Application Ref: NP/21/0102/FUL

Agent Mr A Vaughan-Harries, Hayston Development & Planning Proposal Demolition of existing residential dwelling house and

Site Location Ringstone, Haroldstone Hill, Broad Haven,

A2122 - RINGSTONE - REAR BEDROOM WINDOW SET BACK SKETCH

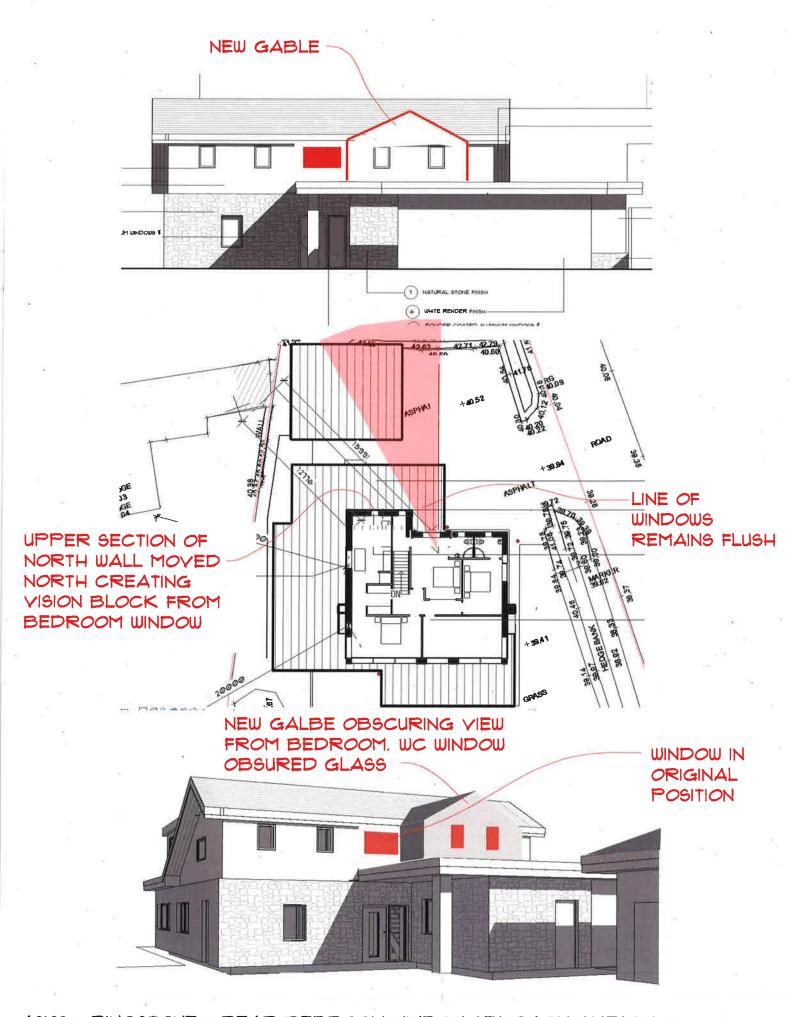
The distance between the rear master bedroom window (on the northern elevation) and the adjacent property's south facing windows is approximately 14.8 metres at an oblique angle. The agent has stated that due to the areas of flat roof, this will protect the amenity of the adjacent property as overlooking will not be possible.

A further amendment to the proposed dwelling to introduce a first-floor gable on the north west corner of the dwelling has been submitted in order to address concerns over the potential for privacy and overlooking. This gable extension will limit the potential for views from the rear master bedroom window on the north elevation, and the windows to the en-suite are now labelled as being fixed and obscure glazed.
